**Planning Commission
Work Session
October 28, 2021 – 5:00 p.m.
233 South Main Street, Monroe, Ohio**

Work Session regarding Hyde Park at the Crossings, a proposed residential development at Roden Park Drive and Crossing Boulevard.

I. Administrative Report—Hyde Park at the Crossings Residential Development

RE: Hyde Park at the Crossings
Planning Commission Work Session

OWNER : MUHLHAUSER WHITE HOUSE LLC P.I.D. M5620252000408

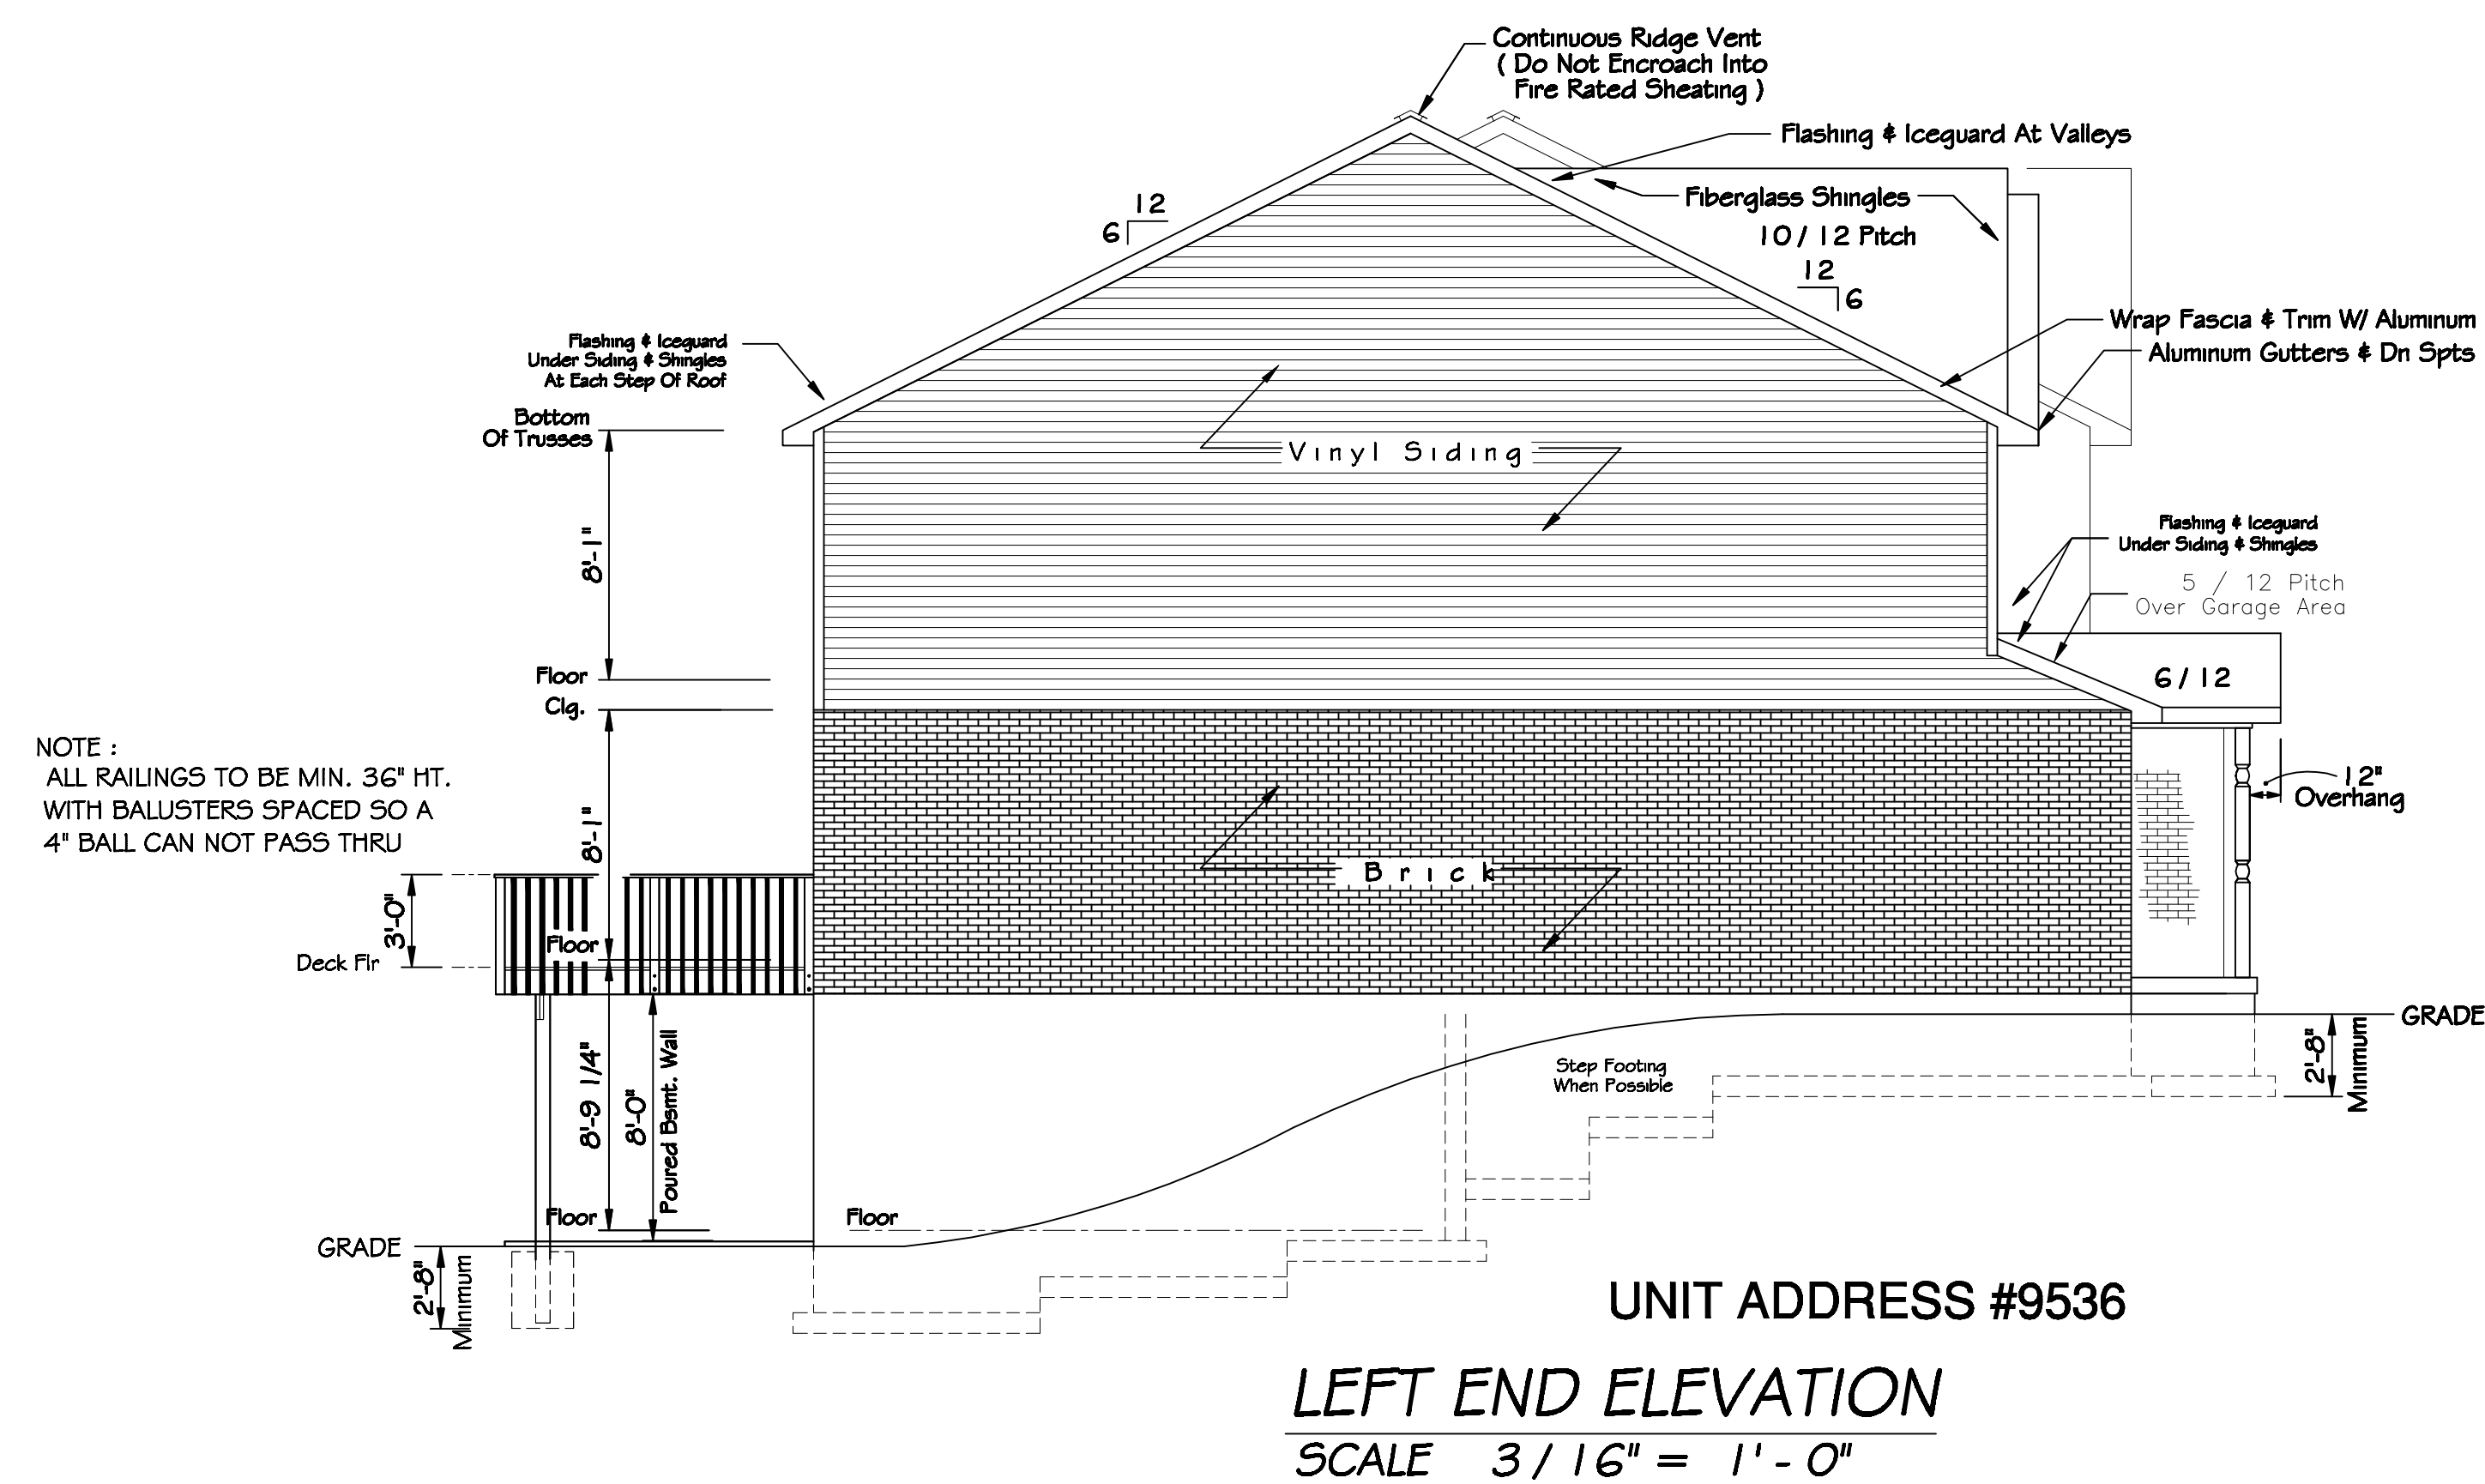
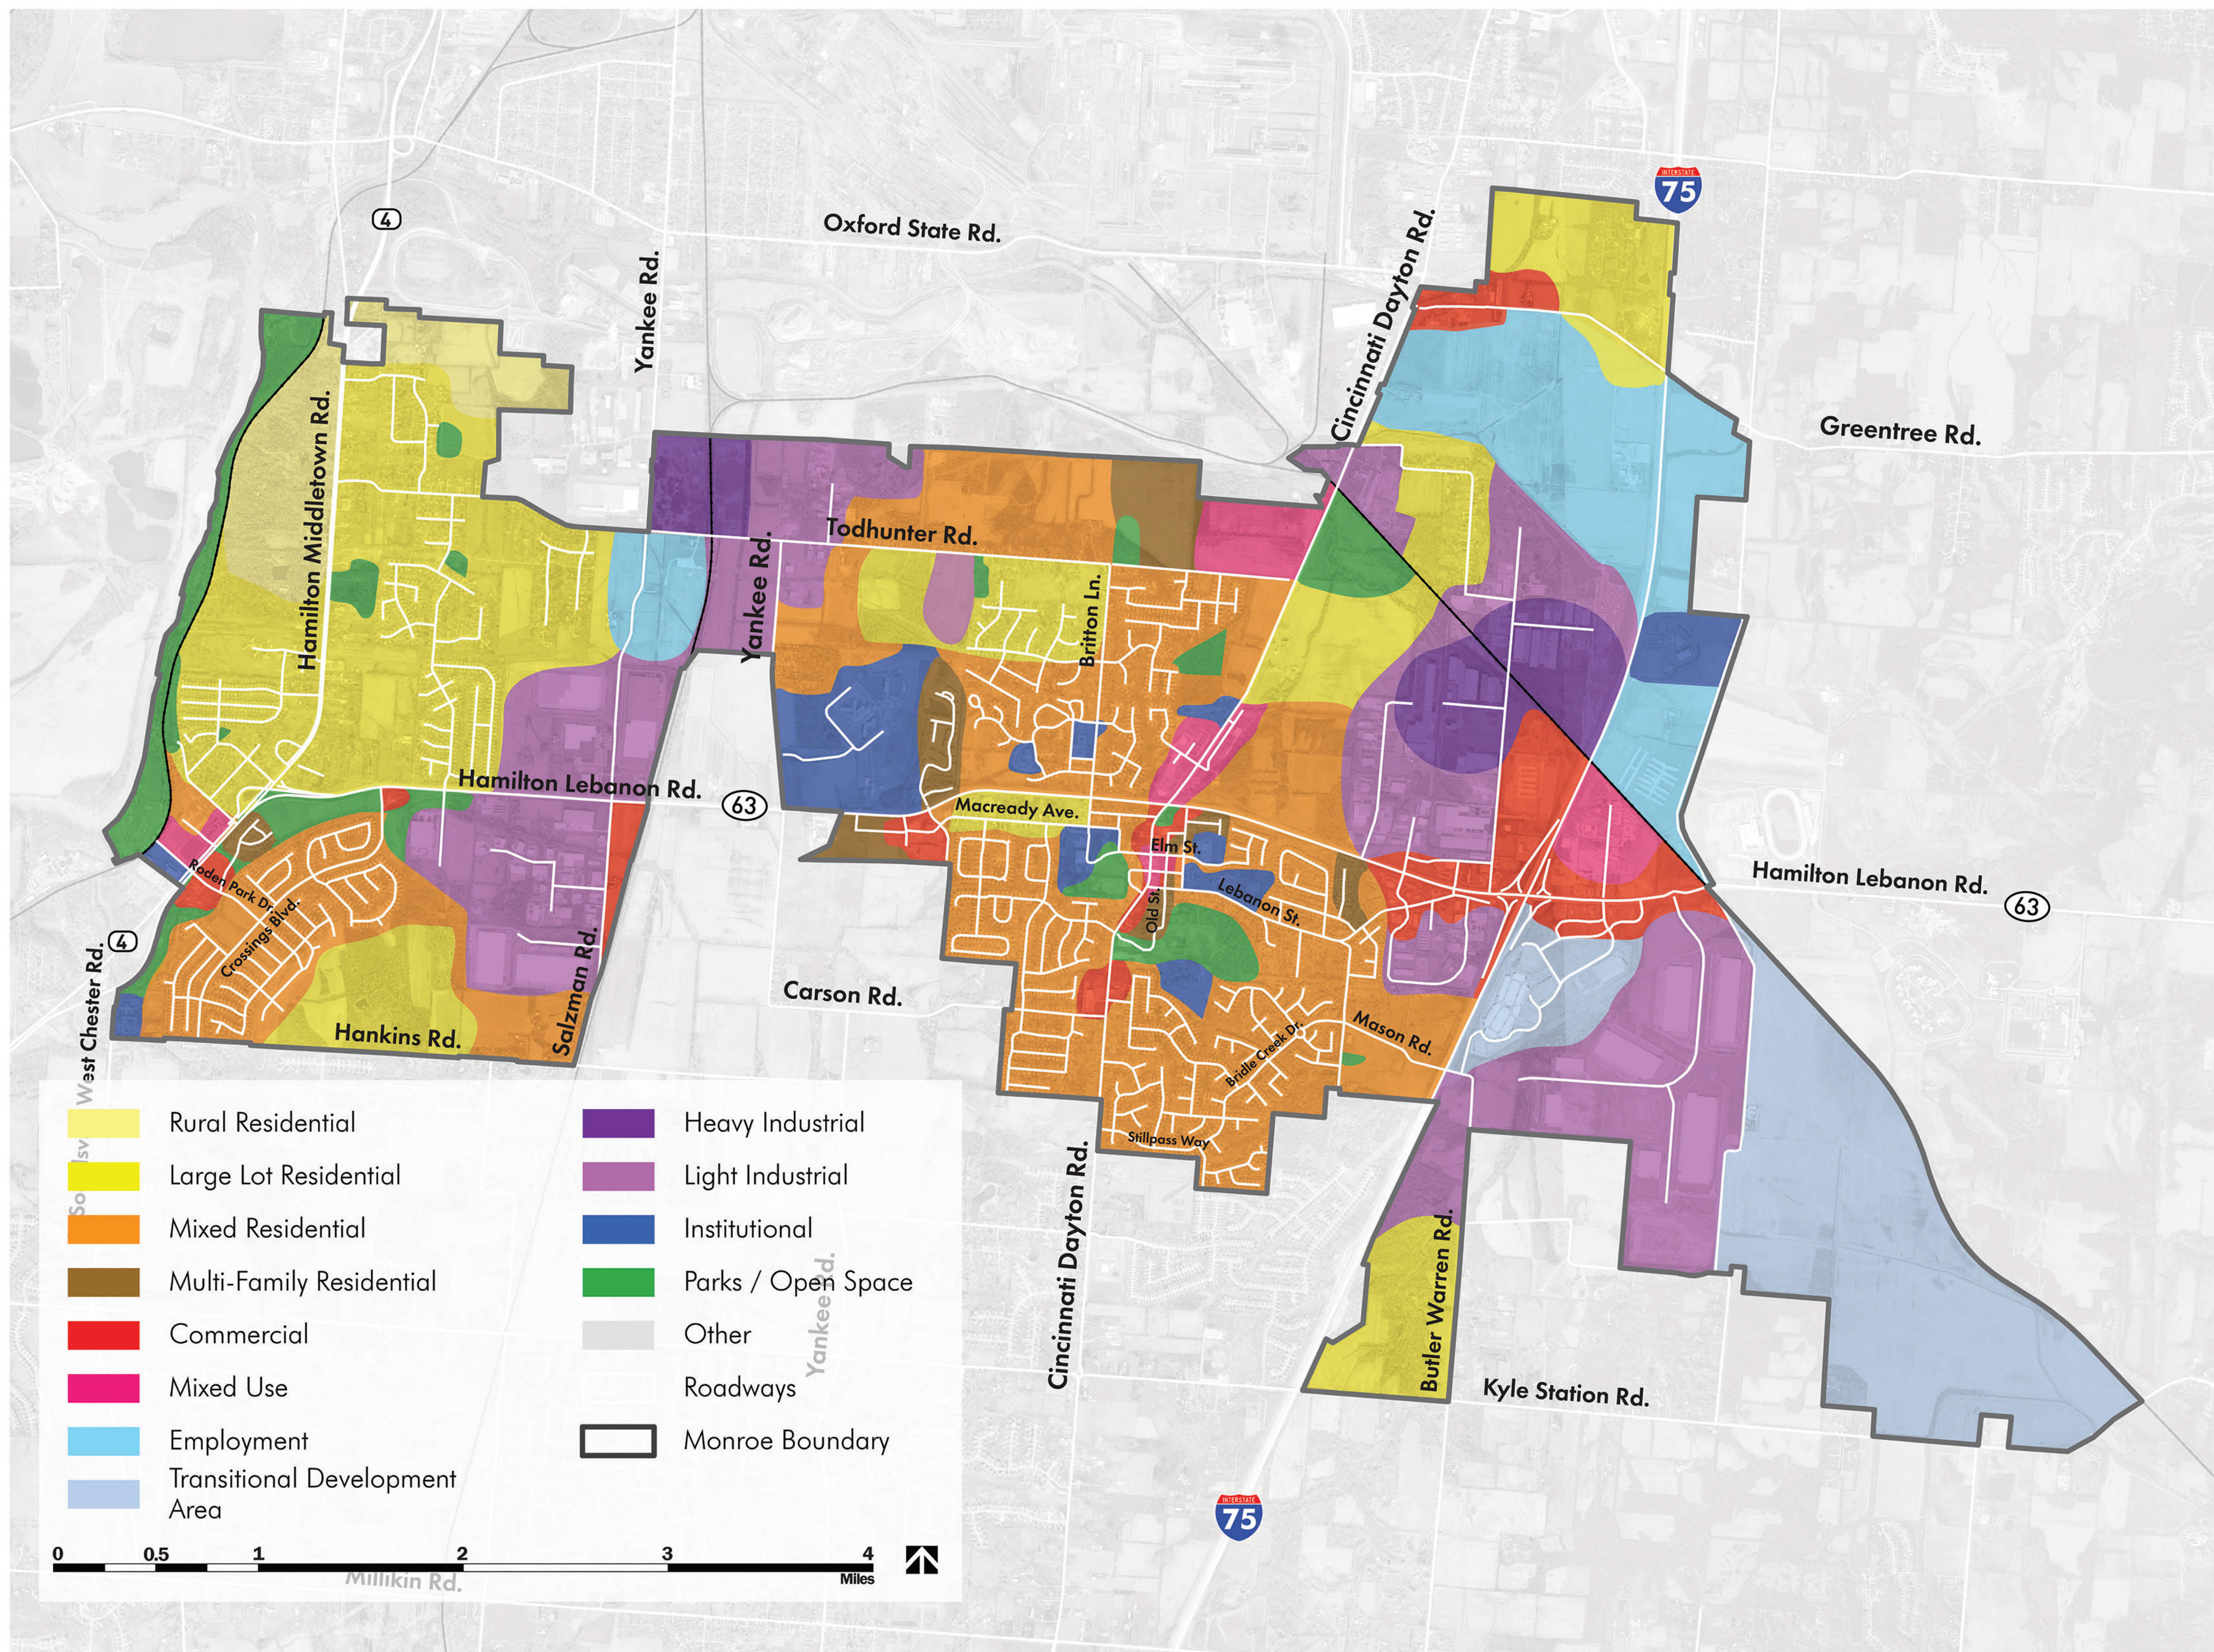
- Based on renderings provided, it appears some of the models have more than 25% siding permitted on the front elevations. The maximum on front elevations is 25%, with 75% required to be brick or stone.

- Front elevations must incorporate variation in mass through methods such as wall offsets 2 feet deep, bay windows, façade color changes, use of pilasters/columns, roofline changes, etc. Based on information provided, it appears wall offsets, façade color changes, columns/pilasters, and roofline changes have been incorporated.

- Side and rear elevations must contain a minimum 50% brick or stone. This requirement has not been met.
- Front and side facades (on buildings located on corner lots) must include a combination of design elements such as dormer windows/cupolas, recessed entrances, covered porches, pillars/posts/pilasters, bay windows, multiple windows with minimum four inch trim, etc. The front elevation does appear to show multiple windows, recessed entrances with covered porches, and pillars/posts, but side elevations do not meet this requirement.

- Vinyl is proposed for this development, which is currently prohibited per code.

THE OVERLOOK

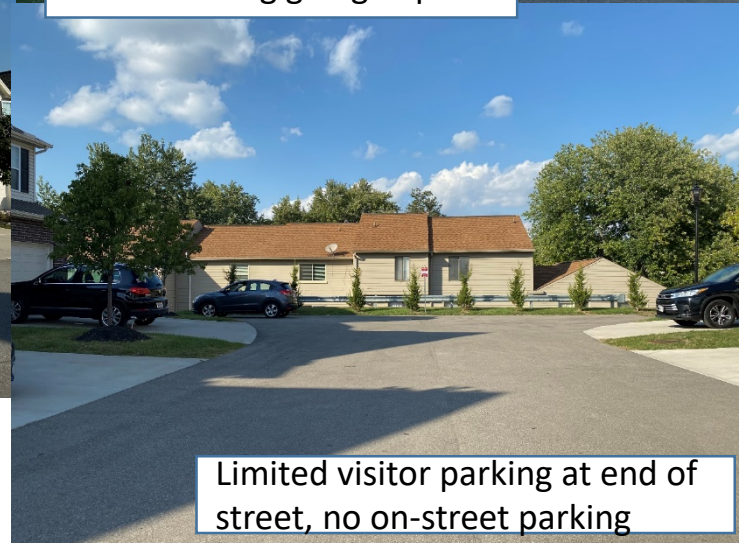
Somewhat material, but monotonous design

Limited sidewalks, no curb or street trees

No rear facing garage option

Limited open or amenity space

Limited visitor parking at end of street, no on-street parking
